Access Compliance Report Public Rights-of-Way (Pedestrian Signals)

Main Street: **IRVINE_AVE** Cross Street: **UNIVERSITY_DR** Location: **E**

ADA ID: **SGRK211018114445** Signal Type: **One Push Button-Non APS** Overall Compliance: **No** Severity Scores: **BTN 1: 35** **BTN 2: N/A** **No BTN: N/A**

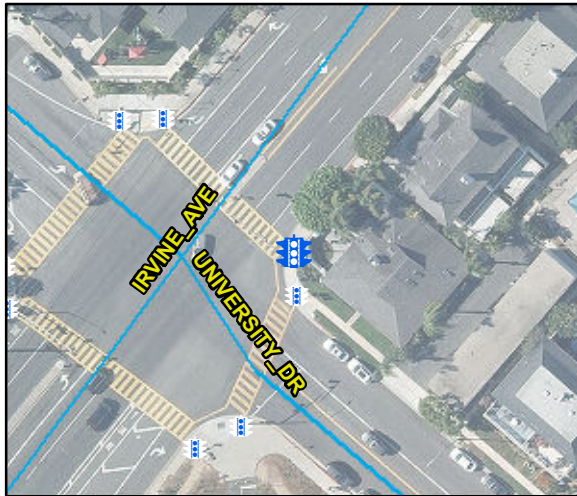
Possible Solutions: Replace Signal Push Button With APS Button. Remove and Replace Clear Space.
